SR 525

MUKILTEO FERRY TERMINAL (PHASE 2) FERRY TERMINAL CONSTRUCTION

VOLUME 5 OF 8

VOLUME 5 SHEET INDEX

1 LEVEL 1 SECTOR B LIGHTING PLAN

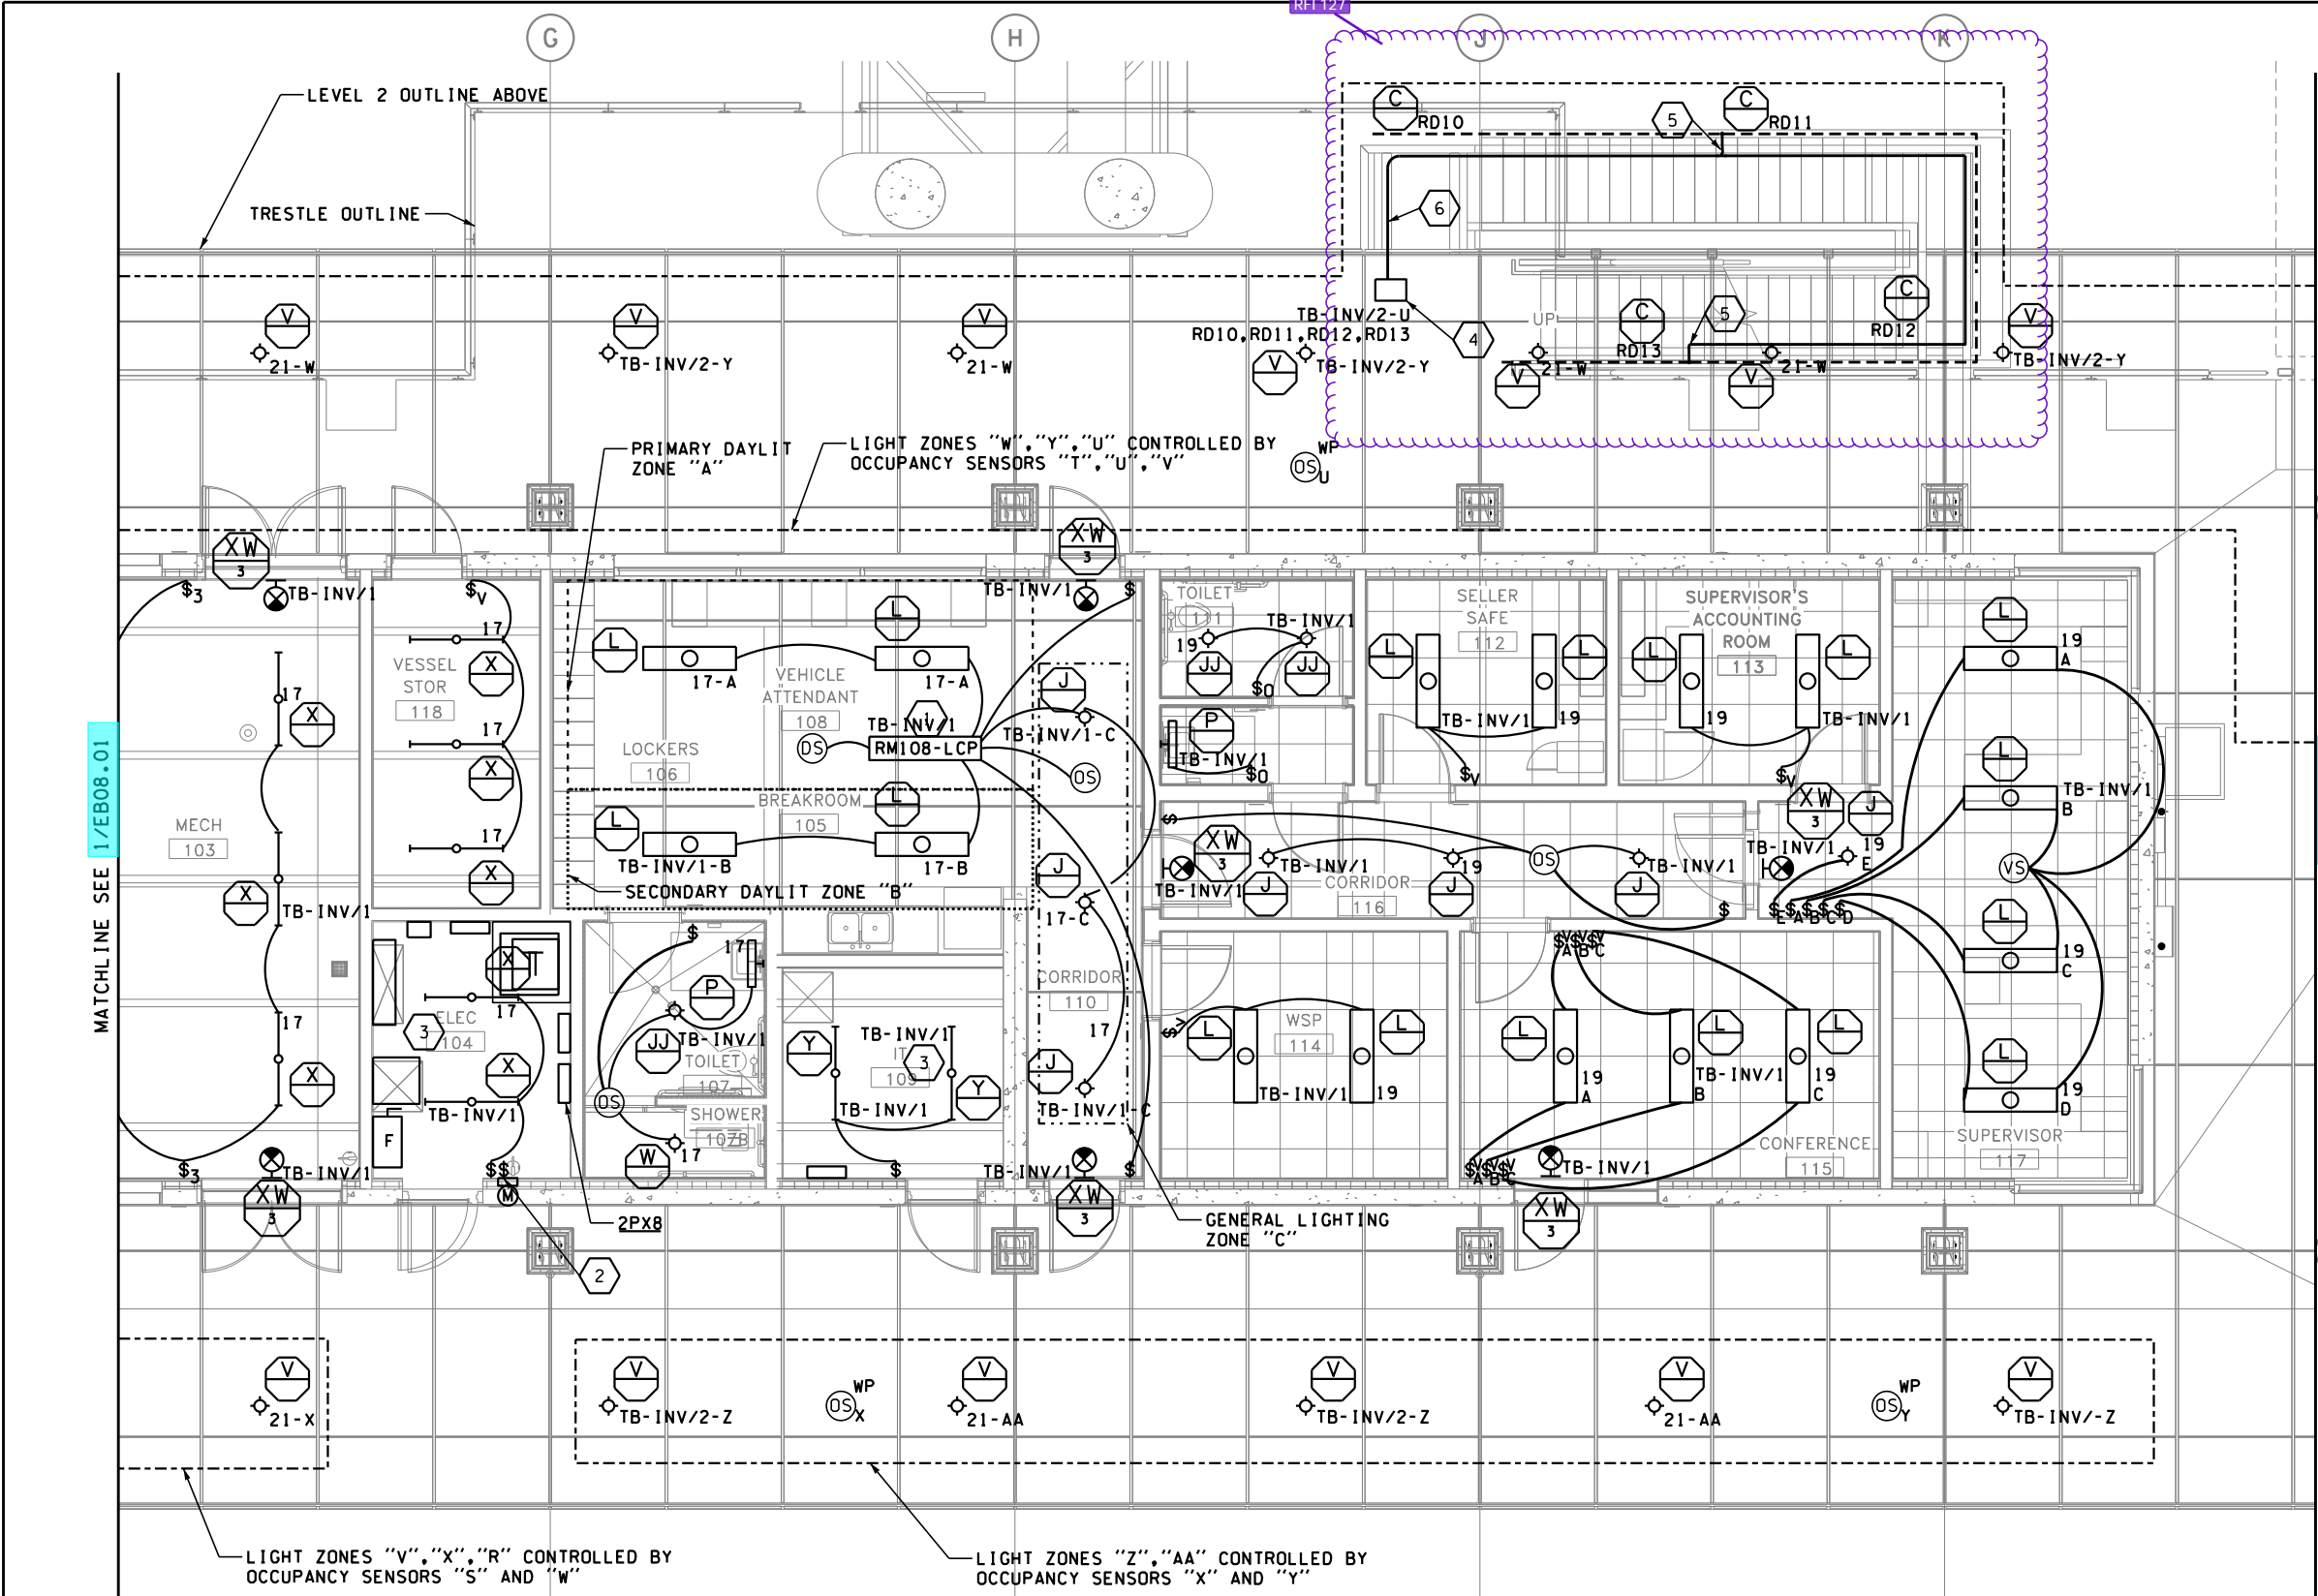
RFI 127 - Additional Guardrail Questions
Sheets A04.11, A06.17 and A06.18 have been revised as part of the response to this RFI.
1- See 1/SB06.09

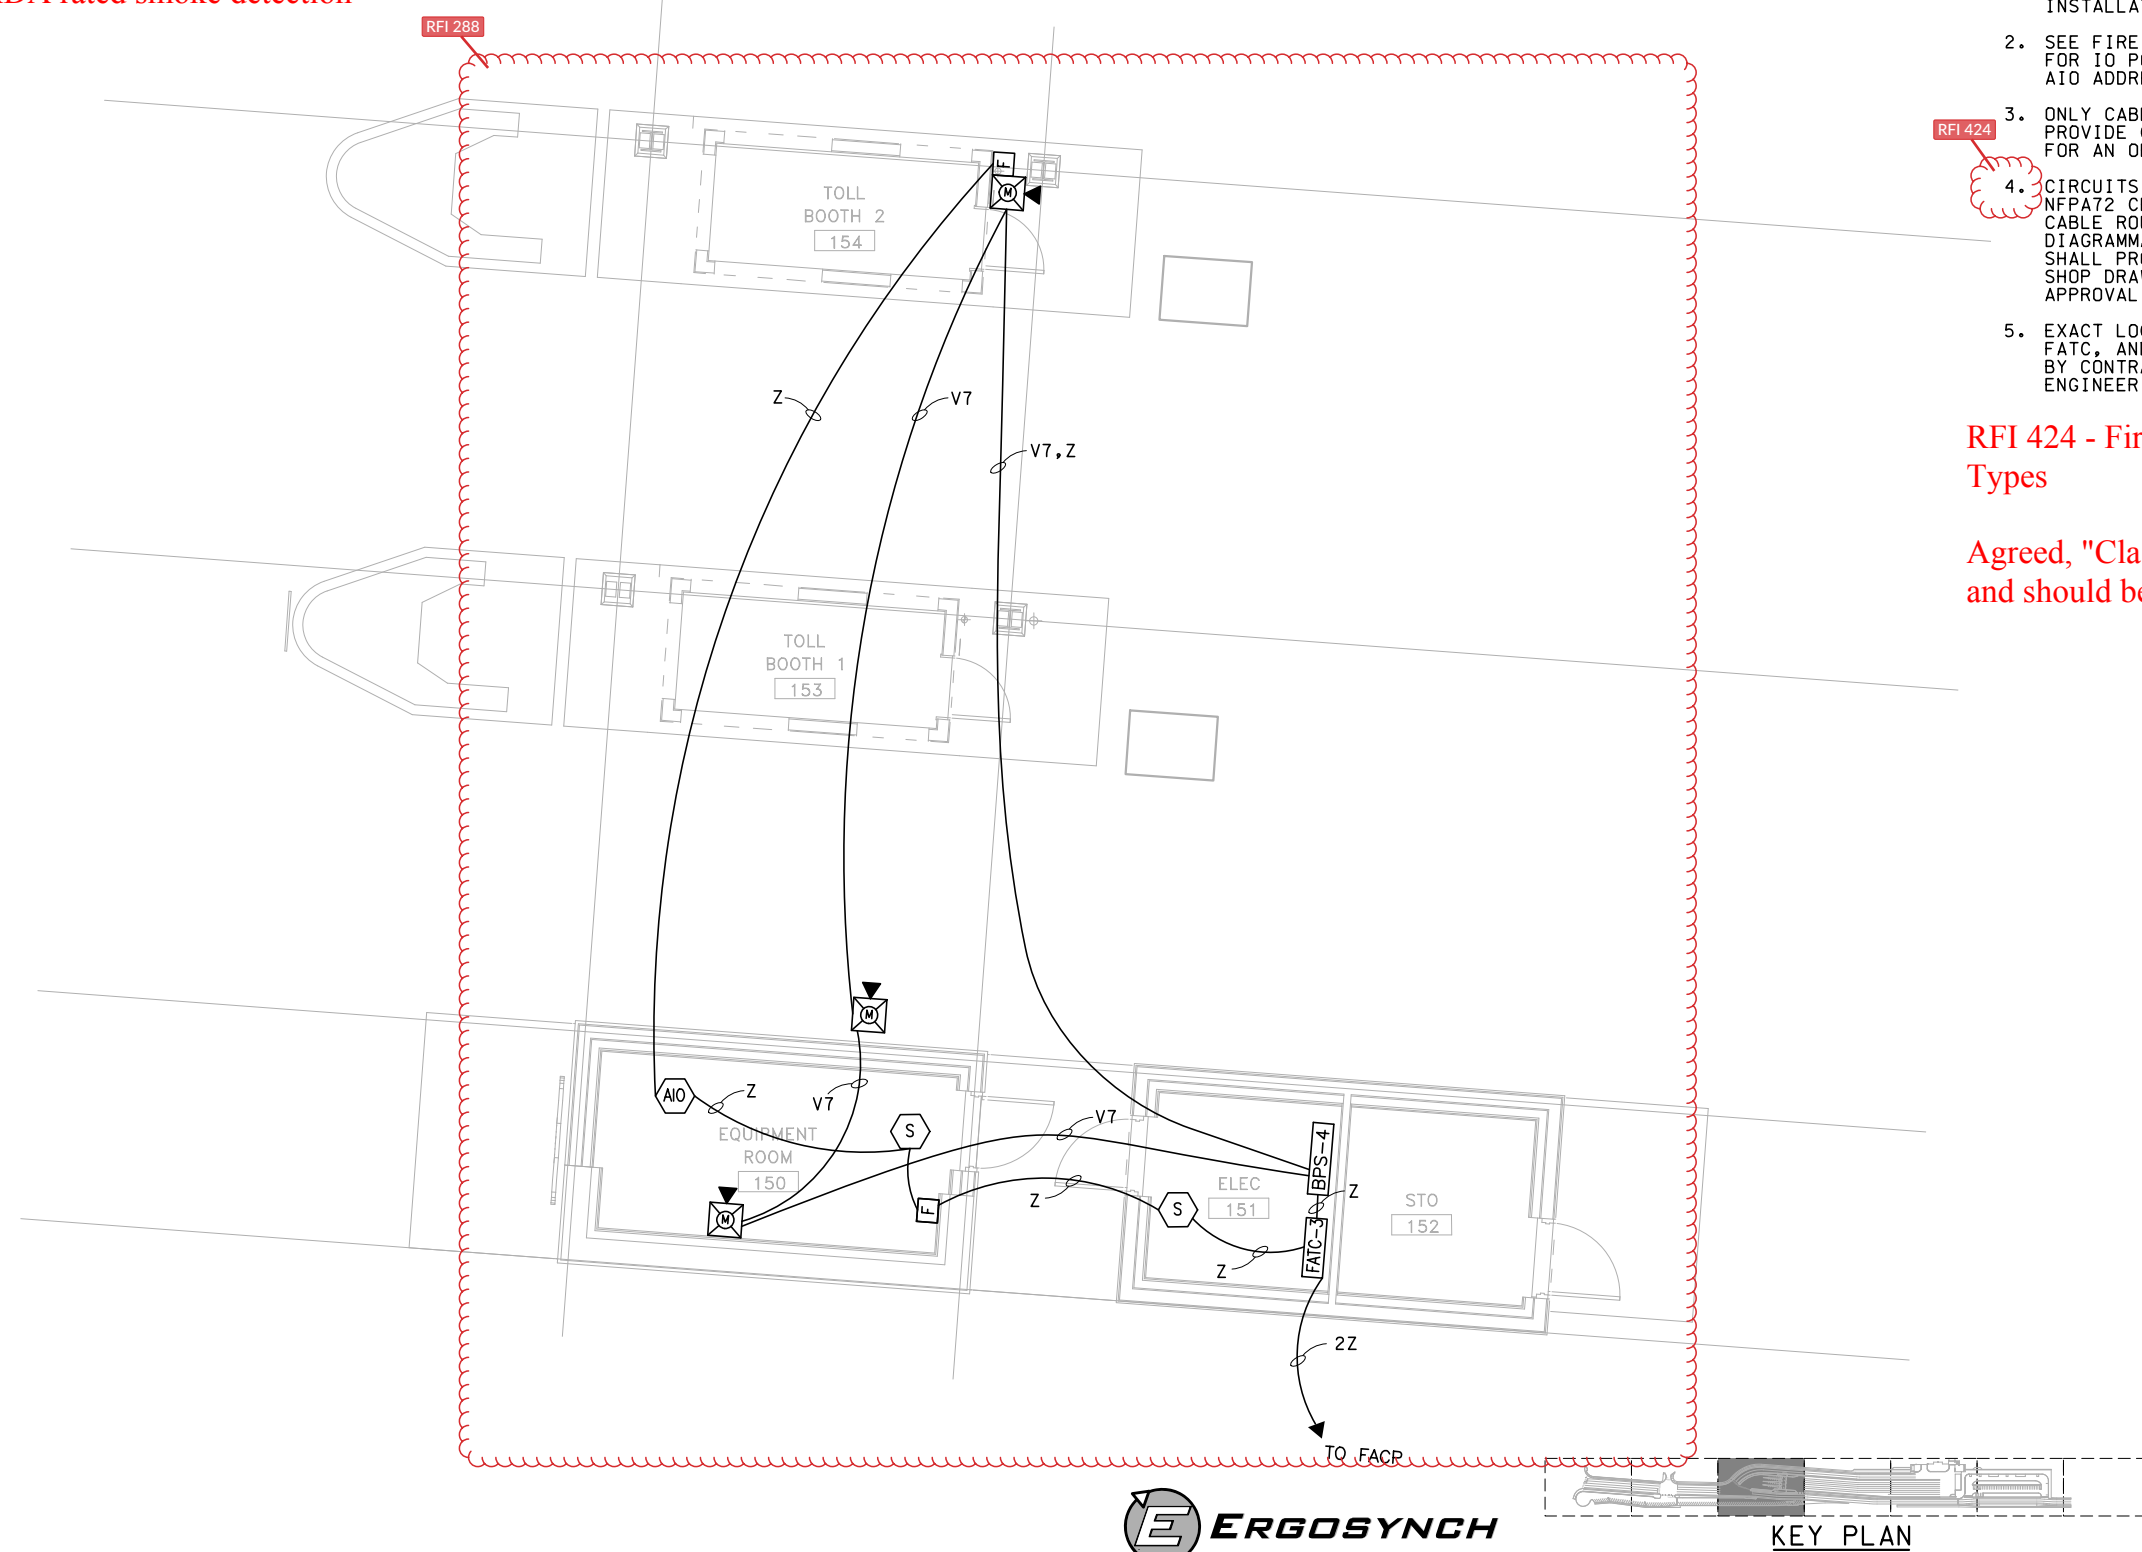
Each toll booth shall have smoke detection and the ADA bathroom shall have ADA rated smoke detection and horn/strobe.

Agreed, "Class A" is preferable and should be used.

RFI 403 - UPS Downsizing

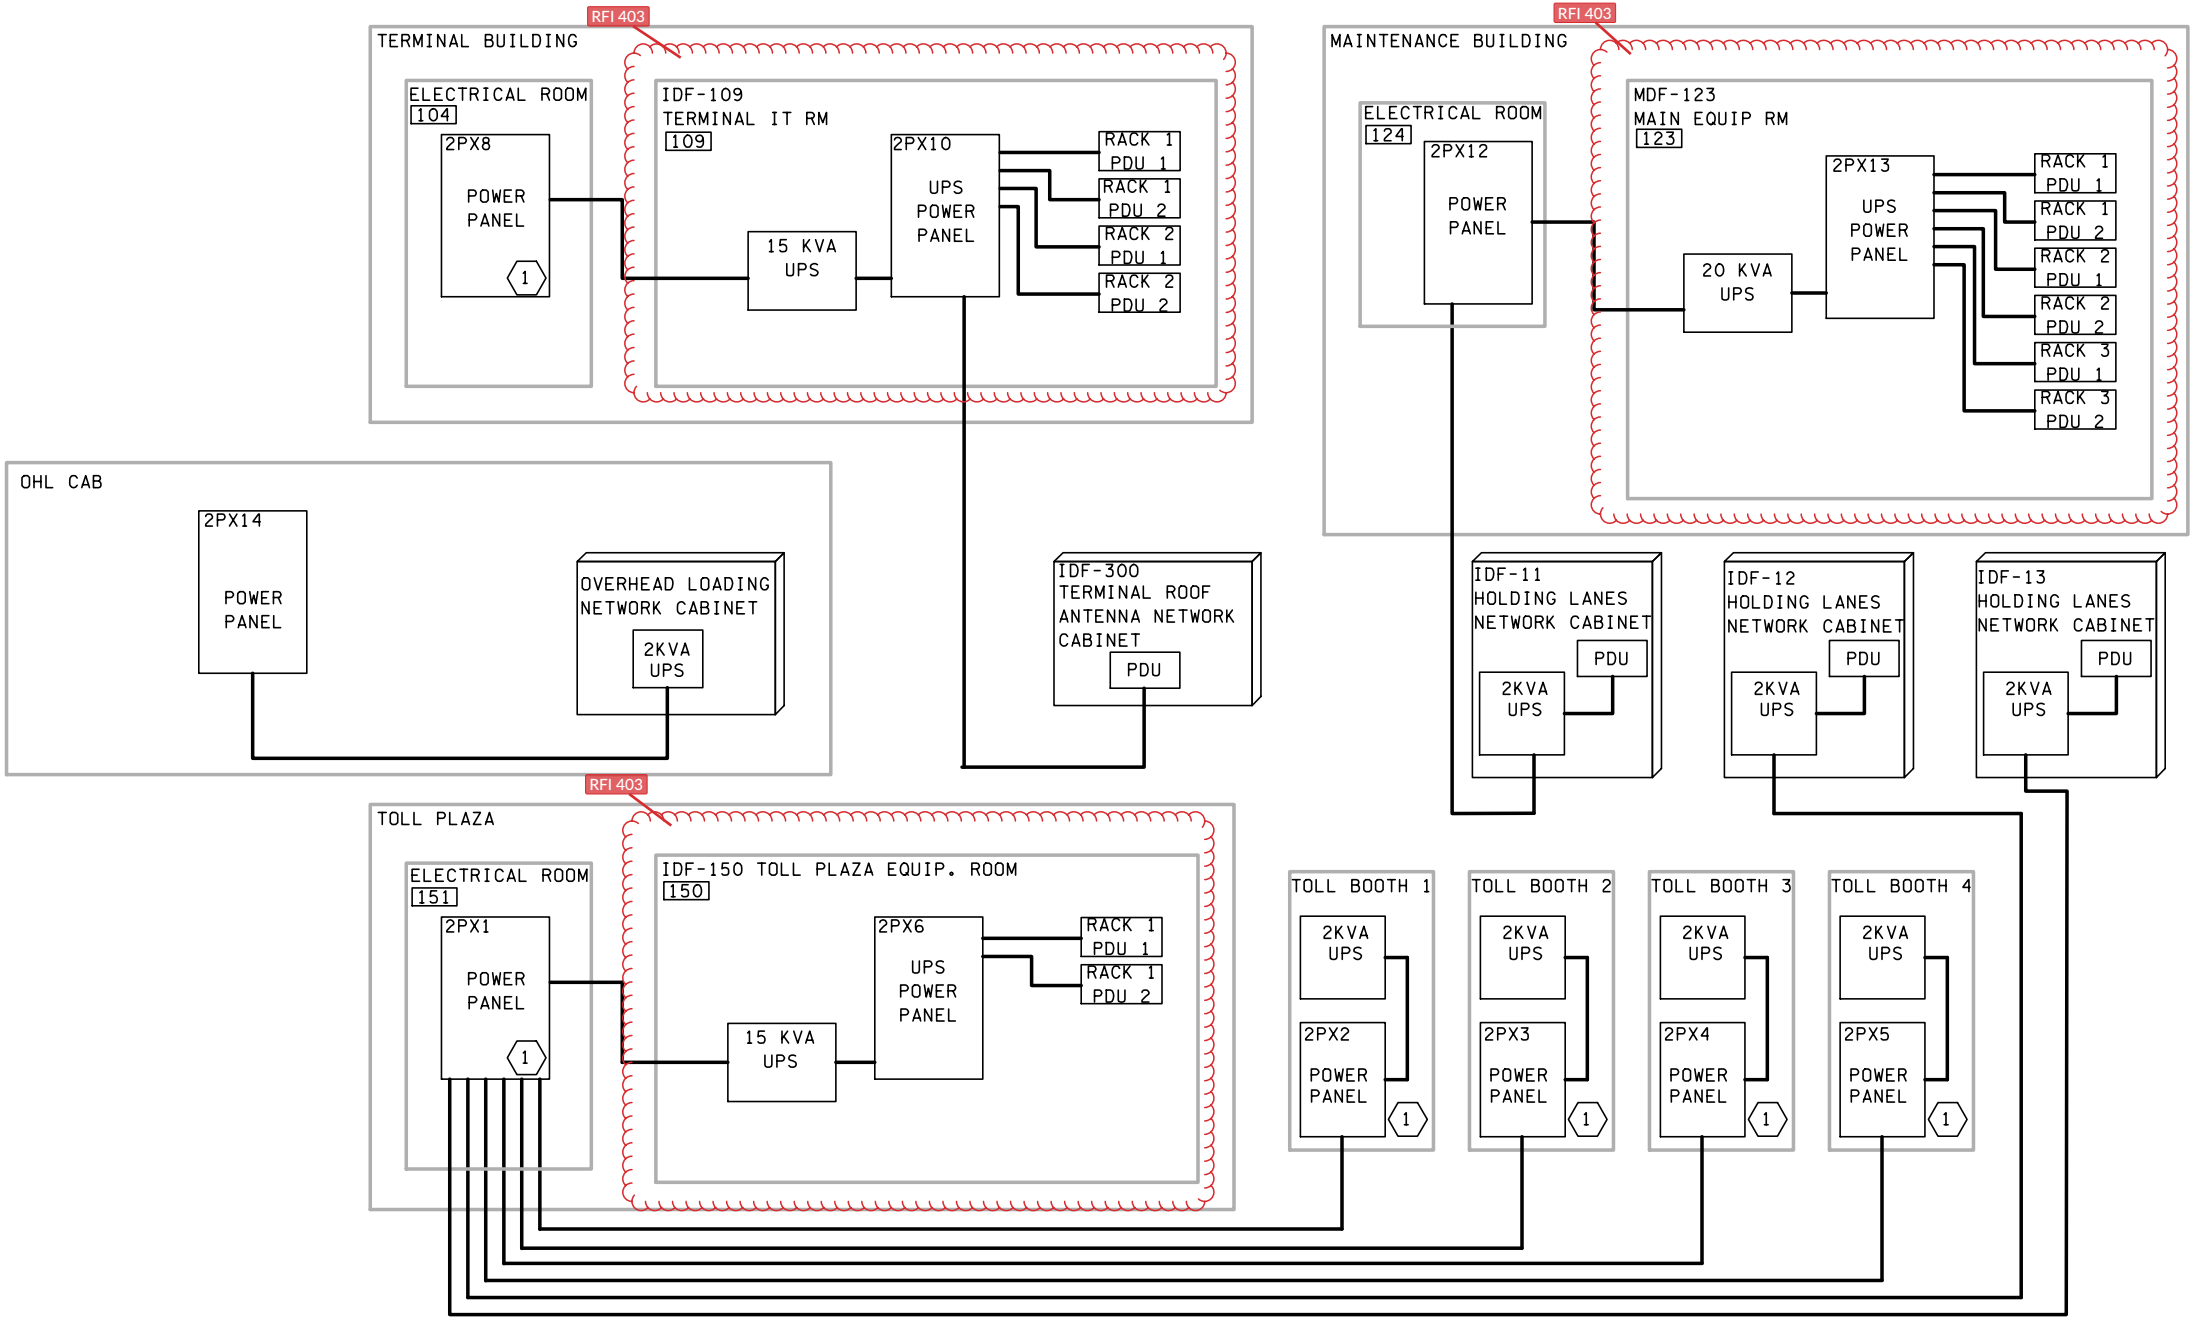
In our recent construction meeting information was shared indicating all systems of EZI (communication subcontractor) scope will be supported with backup generators. The specified battery backups for 20 KVA in MDF-123 and 15 KVA in IDFs 109 & 150 referenced in specification 27 05 27 2.3.A are of significant size that will be problematic to install in the limited available space for them. It is EZI's opinion that the specified UPSs are not just large, they are significantly oversized for the demand since their only function will be to provide power long enough for systems to cut over to the generators in the event of a loss of power. Since even the smallest rack mount UPS takes up 2 rack spaces in a cabinet or rack, the Cyberpower PR2200LCDRTLXL2UTAA UPS should be more than ample (in EZI's opinion) battery backup for all applications of this project and is part of our product submittals for use in toll booths and other IDFs as shown on drawing EB11.09. Please confirm the MDF-123, IDF-109, and IDF-150 can be adequately supported with a 2 KVA UPS and a credit proposal will be prepared for review.
